3.7 Seismic Design

MIC-03-03-00066

MIC-03-03-00054

Figure 3.7.1-1 US-APWR Horizontal CSDRS

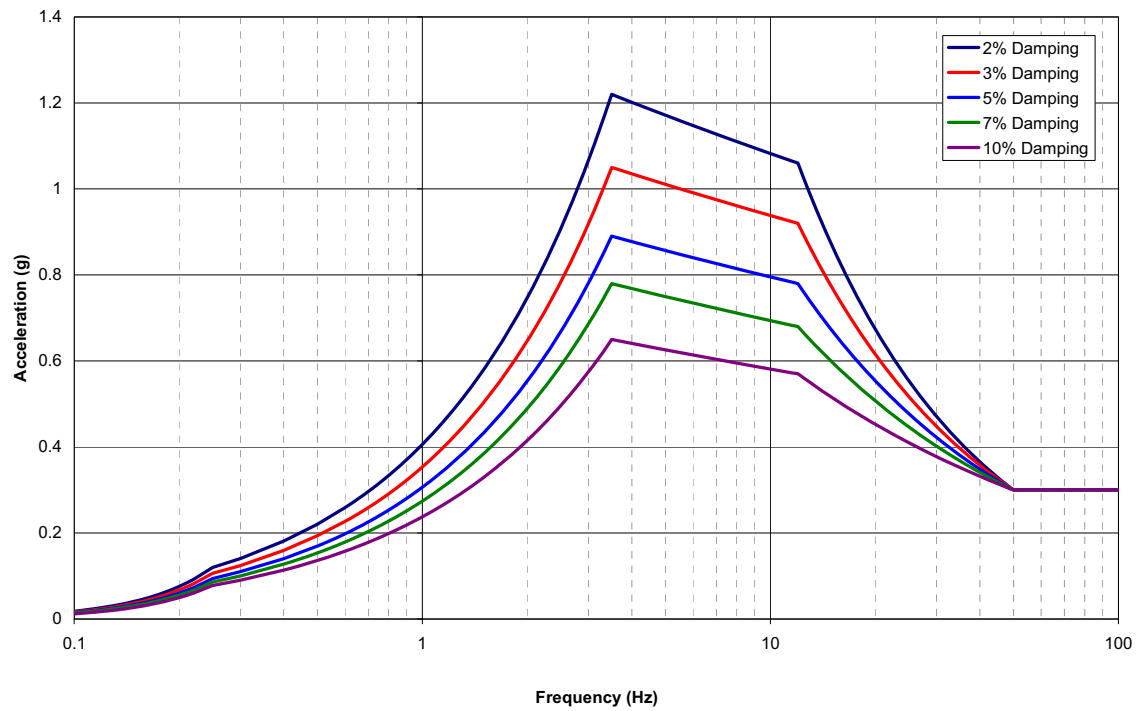
The site-independent CSDRS that are employed for the seismic category I design of the US-APWR standard plant are shown for 0.5%, 2%, 5%, 7%, and 10% damping values in Figures 3.7.1-1 and 3.7.1-2 for the horizontal and vertical components, respectively. The CSDRS are derived from RG 1.60 (Reference 3.7-6) spectra by scaling the spectra contained in RG 1.60 from 1.0 g to 0.3 g zero period acceleration (ZPA) values, and by modifying the RG 1.60 control points to broaden the spectra in the higher frequency range. The RG 1.60 spectral values are based on deterministic values for western United States earthquakes. ~~However, recent seismic research including recently published attenuation relations~~ NUREG/CR-6728 (Reference 3.7-14) indicates that earthquakes in the central and eastern United States (CEUS) have more energy content in the higher frequency range than earthquakes in the western United States. Thus, the RG 1.60 (Reference 3.7-6) spectra control points have been modified by shifting the control points at 9 Hz and 33 Hz to 12 Hz and 50 Hz, respectively, for both the horizontal and the vertical spectra. Therefore, for the US-APWR CSDRS, the horizontal spectra control points are at 0.25, 2.5, 12, and 50 Hz and the vertical response spectra control points are at 0.25, 3.5, 12, and 50 Hz. The modified RG 1.60 (Reference 3.7-6) spectra used for the CSDRS are expected to envelope many sites in the central and eastern United States in order to maximize the applicability of the US-APWR standard plant design; however, it is anticipated that there are some site-specific instances, particularly on hard rock sites in high seismic areas, where high-frequency exceedances of the CSDRS may occur. In these cases, the COL Applicant is required to perform site-specific seismic analyses, including a soil-structure interaction (SSI) analysis which may consider seismic wave transmission incoherence ~~and analysis of the cumulative absolute velocity (CAV)~~ of the seismic input motion, in order to determine if high-frequency exceedances of the CSDRS could be transmitted to SSCs in the plant superstructure with potentially damaging effects.

Figure 3.7.1-6a ~~5% Damped Time History Response Spectra (H1)~~ Damped Response Spectra Plots for Northridge Mount Baldy Component H1 (180) [NS]

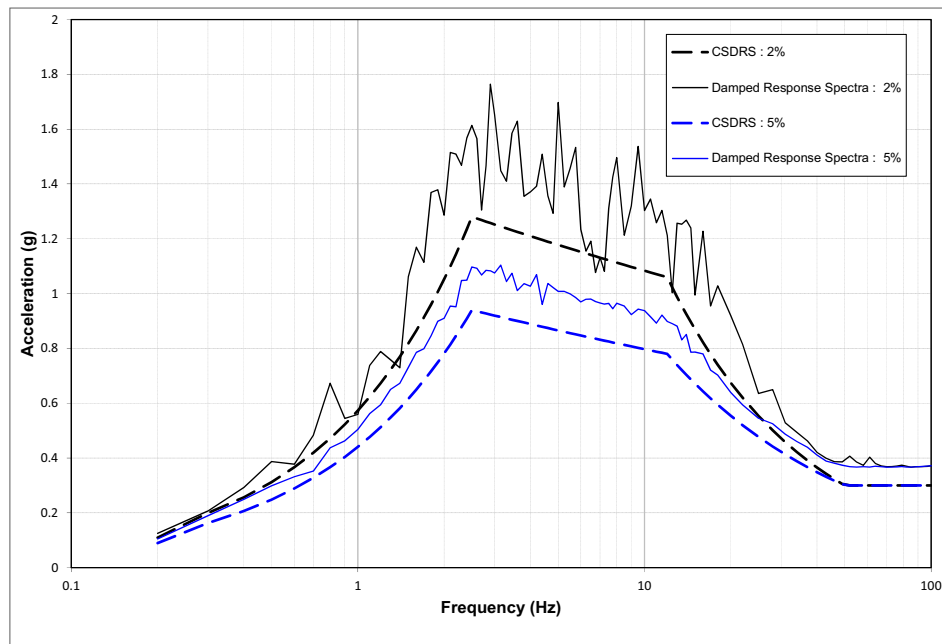
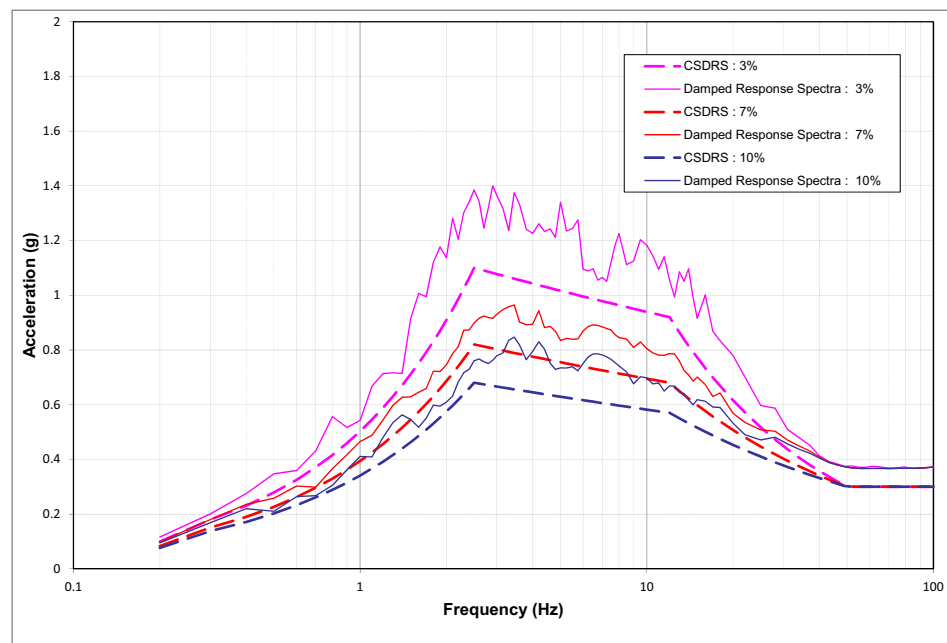
Figure 3.7.1-6 through Figure 3.7.1-8 graphically demonstrate that the response spectra derived from the design basis time histories are developed in accordance with SRP 3.7.1 Option 1, Approach 1, for time history components 180 (H1), 090 (H2), and Vertical (UP), respectively. The response spectra of each component envelopes the CSDRS at 2%, 3%, 5%, 7%, and 10% damping values.

Figure 3.7.2-1 ~~FE Model of PGCV~~ Overview of the PGCV
~~Detailed~~ Integrated R/B Complex Dynamic FE Model

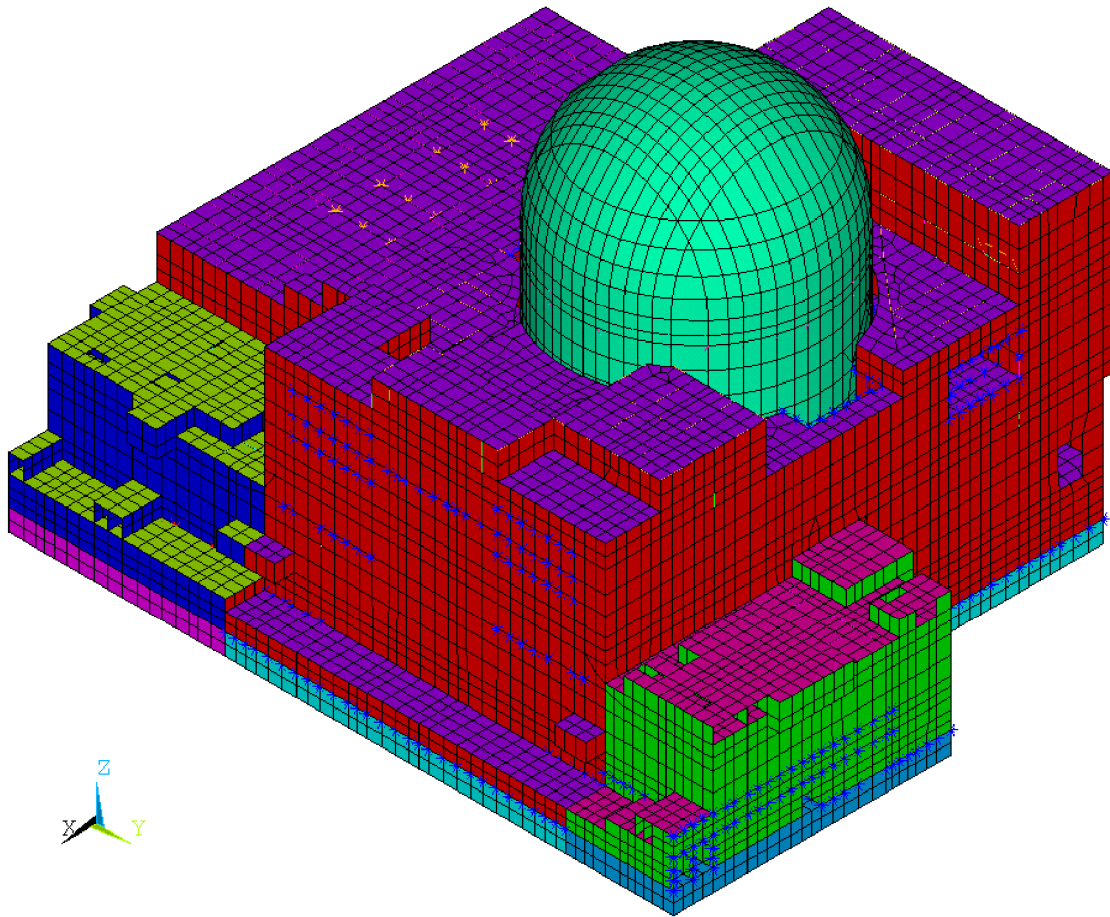
The Dynamic FE model is presented in Figure 3.7.2-1. This model has a total of 33,564 nodes, 47,580 elements and has an average mesh size of approximately 9 ft. The Dynamic FE model is based on the Detailed FE model presented in Figure 3.7.2-2. The Detailed FE model has a total of 62,252 nodes, 74,961 elements, with an average mesh size of approximately 5 ft. Figure 3.7.2-3 and Figure 3.7.2-4 present the detailed PCCV and CIS finite element models, respectively.

The R/B complex Dynamic FE model is an integrated 3-D model of the R/B, PCCV, CIS, East and West PS/B, A/B, and ESWPC structures sharing common shear walls and resting on top of a common 13'-4" to 43'-3" thick basemat. Figure 3.7.2-1 shows an overview of the R/B complex model, while Figure 3.7.2-5 and Figure 3.7.2-6 reveal the interior structures with section views. Figure 3.7.2-7 through Figure 3.7.2-13 show the PCCV, CIS shell elements (excluding the RCL), CIS solid elements, CIS beam elements (excluding RCL), East PS/B with ESWPC, West PS/B with ESWPC, and A/B as individual structures, respectively. The global origin is located at the center of the PCCV and top of the basement with the X axis pointing north, Y axis pointing west, and Z axis pointing upward. Once the model is translated into SASSI format, the global coordinate system is rotated 180 degrees about the Z axis so that the X axis is pointing south and the Y axis pointing east. Typical element size in the basemat and the slabs is approximately 9 ft. The element mesh used in the dynamic model is selected to provide sufficient modeling to capture the dynamic properties of the structure. The validation discussed in Subsection 3.7.2.3.10 show that no further refinement of the Dynamic FE model is necessary.

Figure 3.7.2-7 ~~Method to Calculate Equivalent Shear Area~~ ~~Section View of~~
~~Dynamic R/B Model Looking South~~ PCCV Dynamic Model

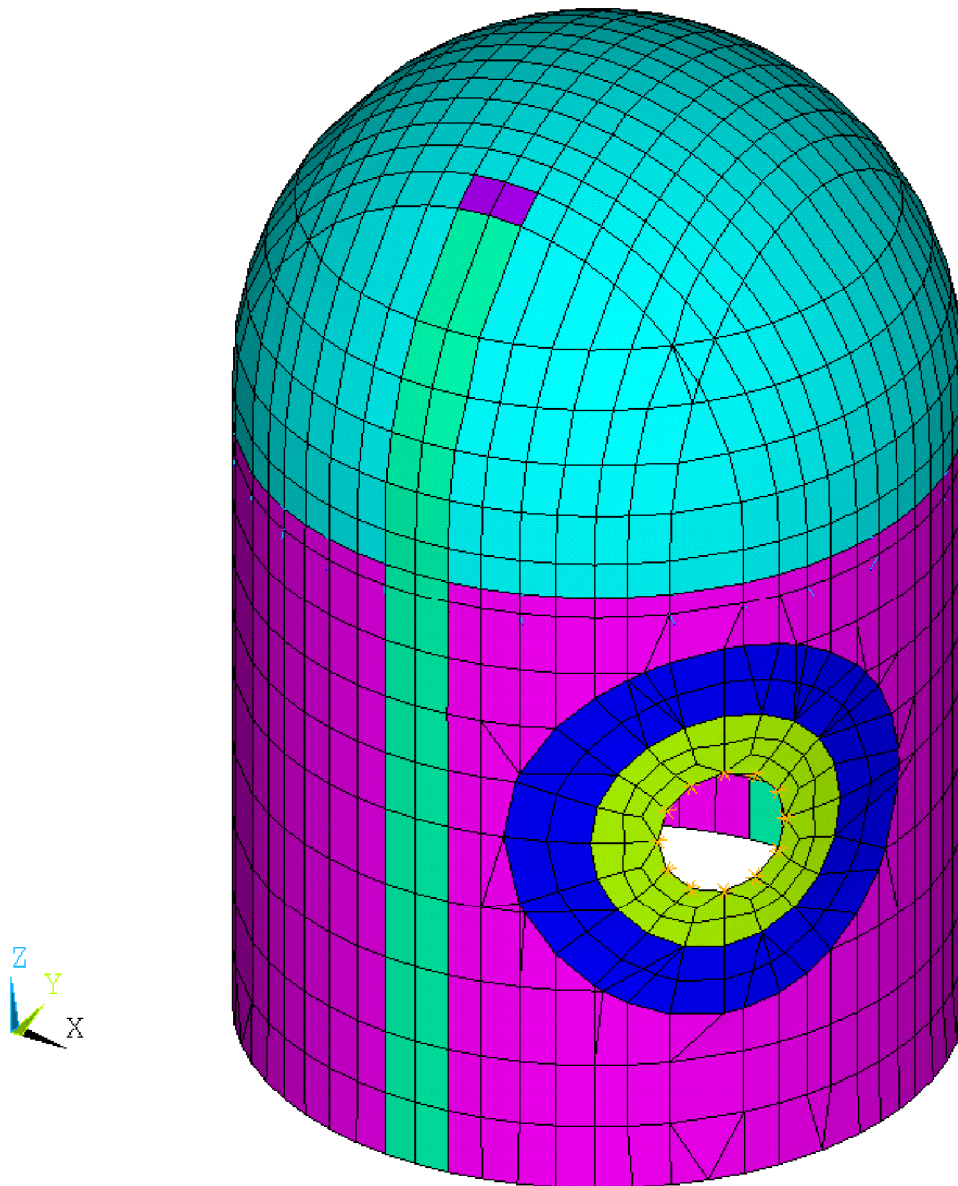
The thickness of the PCCV is also simplified for ease of modeling. For the Dynamic FE model, only the large equipment hatch is modeled and the elements modeling the buttresses on the East and West sides of the structure are not offset with respect to adjacent elements. Also, the personnel airlocks as well as the Main Steam and Feed Water penetrations are not modeled in the Dynamic FE model. The stiffness and weight of the PCCV Dynamic model are not adjusted to account for the openings since they were found to have a negligible impact on the overall response of the structure. Figure 3.7.2-7 shows the PCCV Dynamic model.
